MILITARY SPECIFICATION

BALLISTICS COMPUTER, SUBASSEMBLY: 10543600
(GUNNER'S CONTROL UNIT)

This amendment forms a part of Military Specification MIL-B-60599(MU), dated 18 September 1967.

FIG. 2 TARGET LEAD

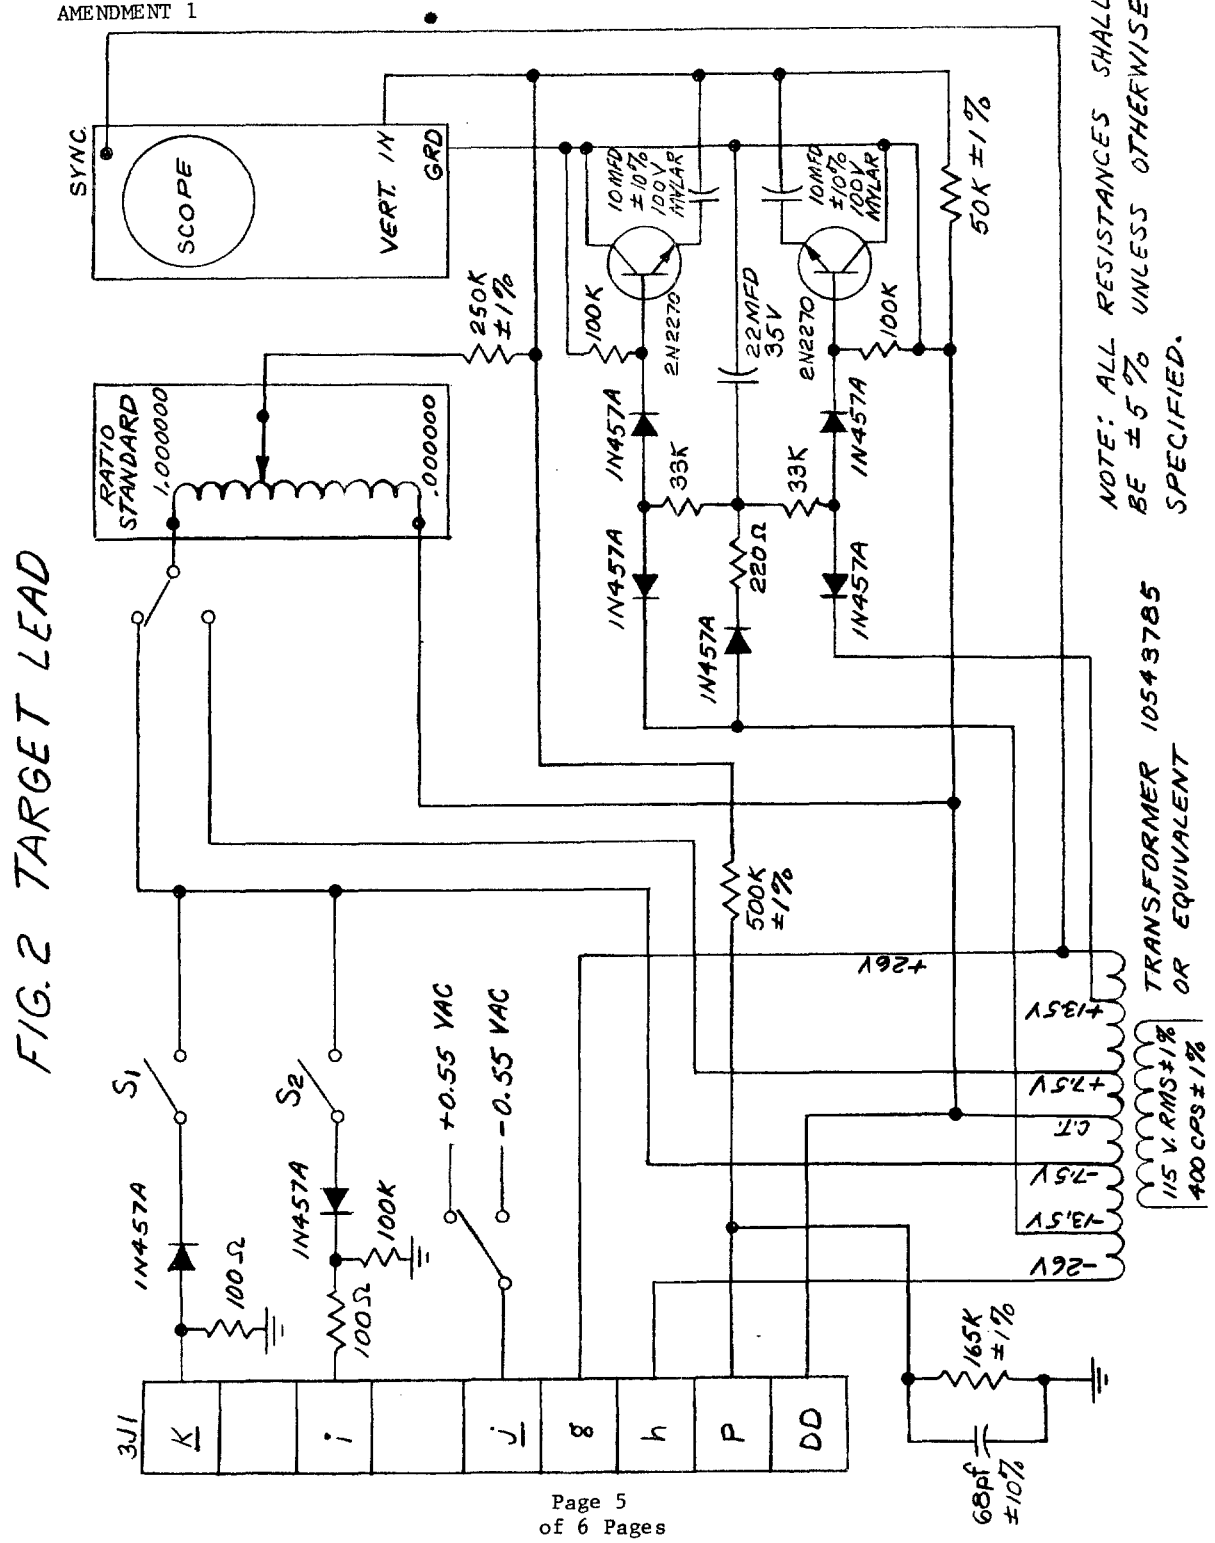
Figure 2: Delete "Figure 2" and substitute revised "Figure 2" (attached).

FIG. 5 RANGE OUTPUT

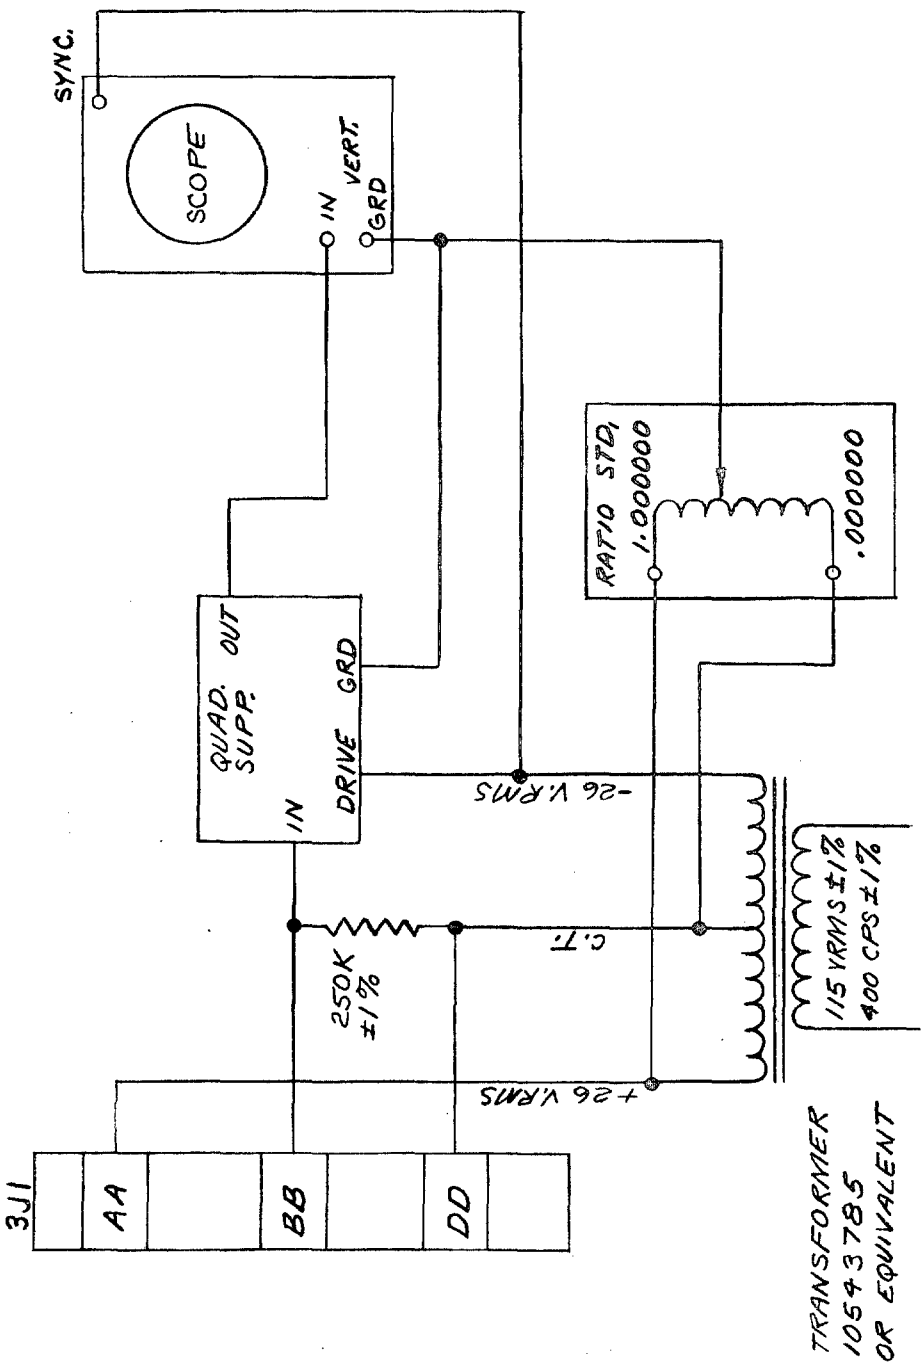
"4.6.13 Range function generator output.- To determine conformance to 3.5.13 after inserting the unit in the test circuit of Figure 5, the output voltages of the gunner's unit range feedback function generator shall be checked for ratio standard null settings at the range dial settings specified in Table VI."

Figure 5: Delete "Figure 5" and substitute revised "Figure 5" (attached).
